# Bulletin

CSB-1011-2  
Country : UK  
Date : 10/5/2006  
APC : D54  
Repair Level : 2

V3V3 05 CR - GSM - RAZR Missing Endcap  
V3 & V3\_05

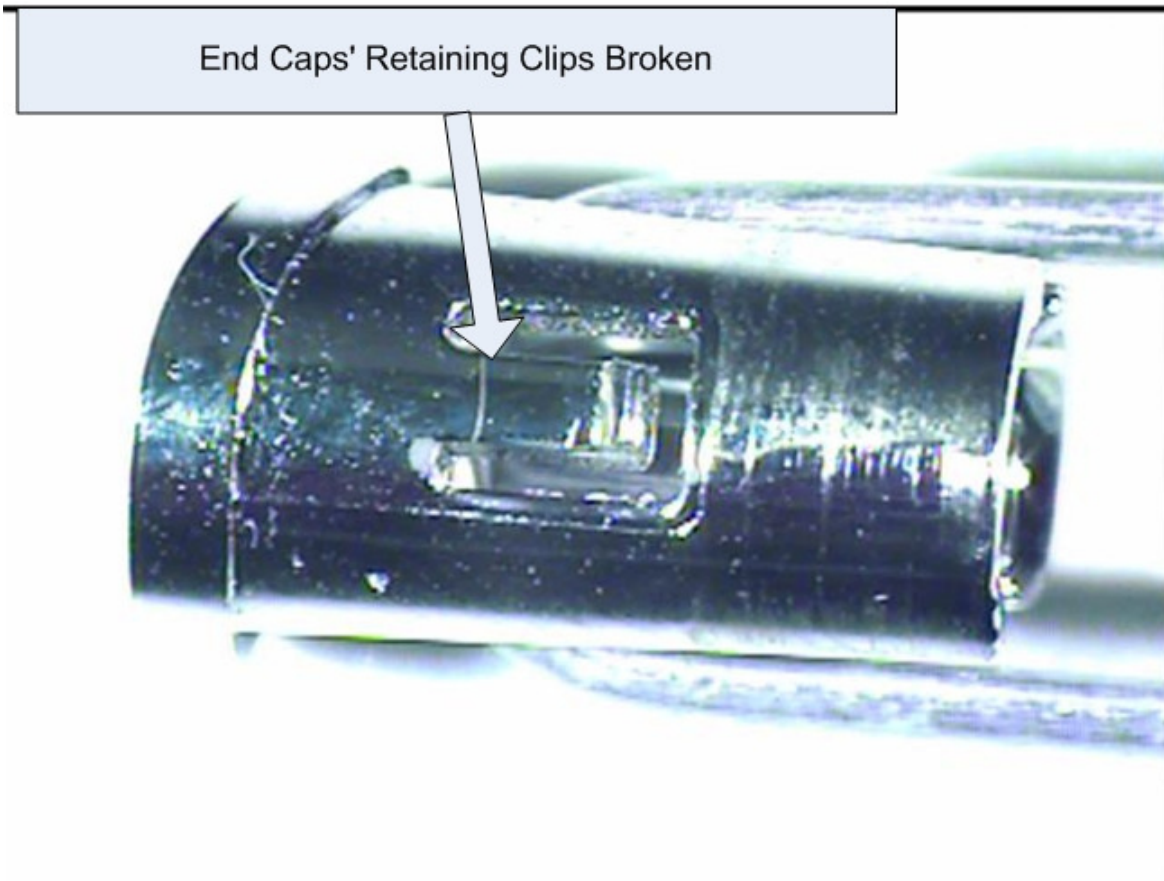
The NA service team has reported a V3 missing/broken/loose end cap issue causing field returns.

The root cause was determined to be end caps' retaining clips getting damaged after disassembly, which were then reused during factory rework and service refurbishment.

The end cap was originally determined to be non-reusable after disassembly. The factory SOP was changed to ensure this part is scrap after disassembly.

When servicing GSM RAZR customer returns with the describe failure the end cap must be replace with a new one. Part # 1589126Y01

Service center must NOT reuse the end cap.
